MICHAEL-MONTLIMAR SUBDIVISION, **RESUBDIVISION OF LOT 2**

APPLICATION NUMBER 15 DATE April 15, 2004
APPLICANT Michael-Montlimar Subdivision, Resubdivision of Lot 2
REQUEST Subdivision

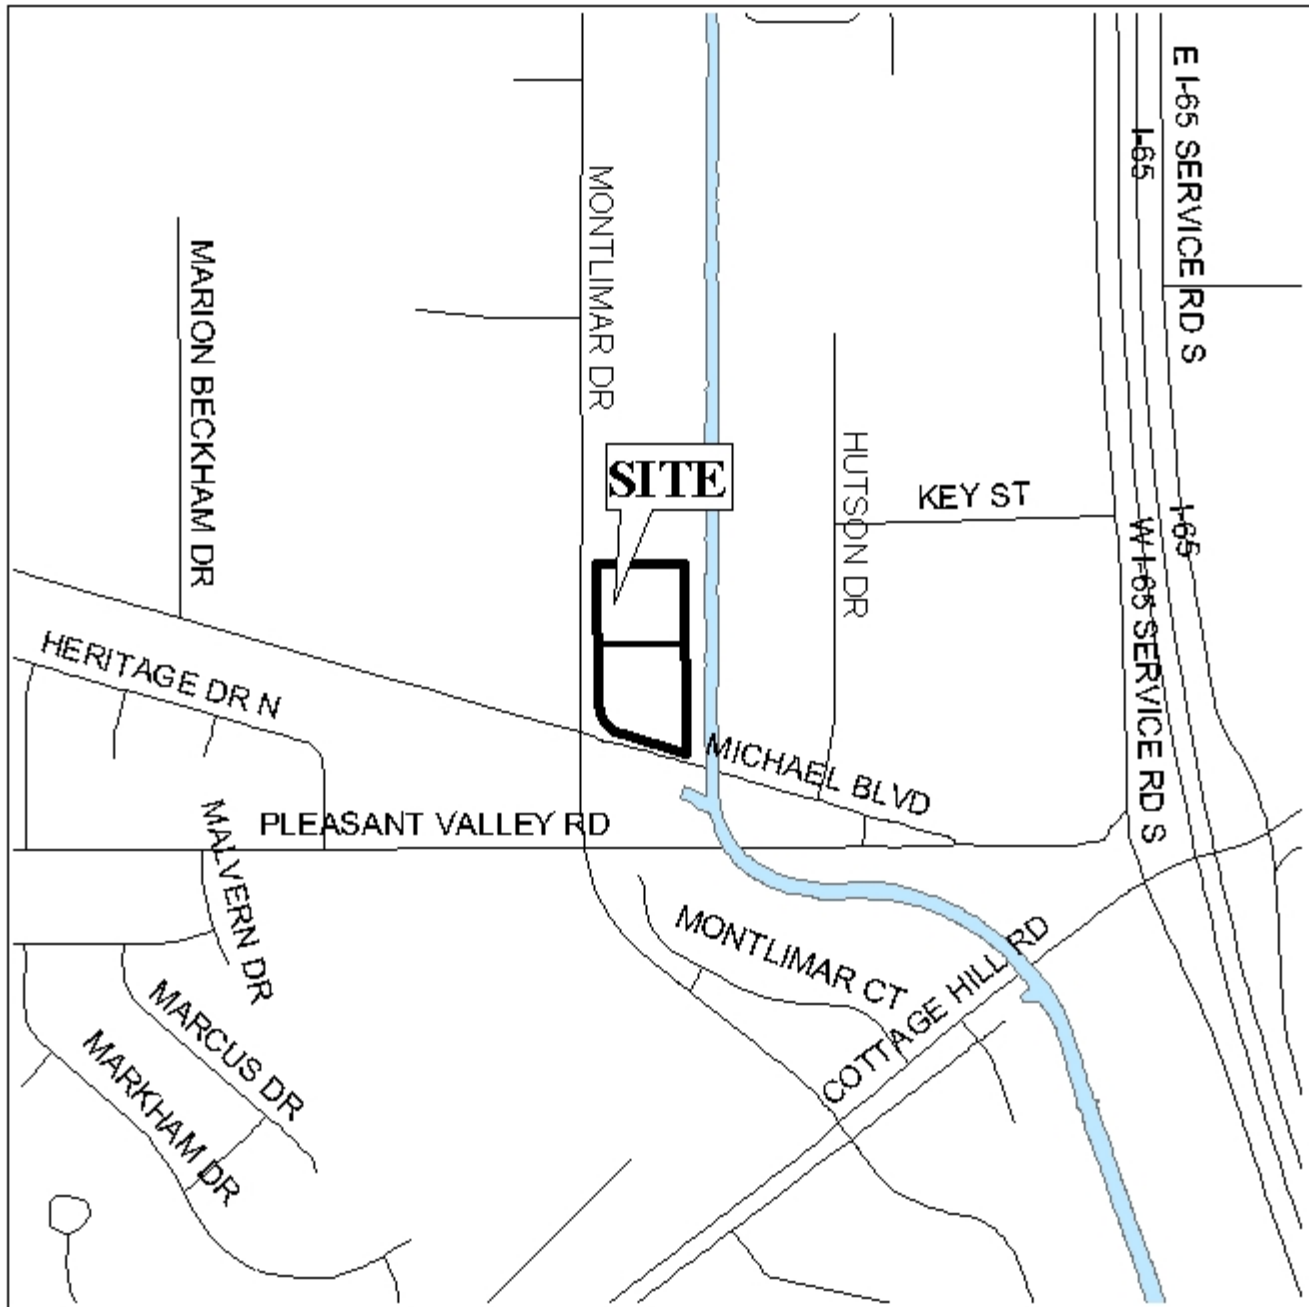
The plat illustrates the proposed 2 lot, 4.3 \pm acres subdivision which is located at the Northeast corner of Michael Boulevard and Montlimar Drive and is in City Council District 5. The subdivision is served by public water and sanitary sewer.

As a means of access management, the placement of a note on the final plat stating that Lot 1 is limited to one curb cut to Montlimar Drive and Lot 2 is limited to one curb cut, with the size, location and design to be approved by Traffic Engineering, should be required.

The plat meets the minimum requirements of the Subdivision Regulations and is recommended for Tentative Approval subject to the following condition: 1) the placement of a note on the final plat stating that Lot 1 is limited to one curb cut to Montlimar Drive and Lot 2 is limited to one curb, with the size, location and design to be approved by Traffic Engineering.
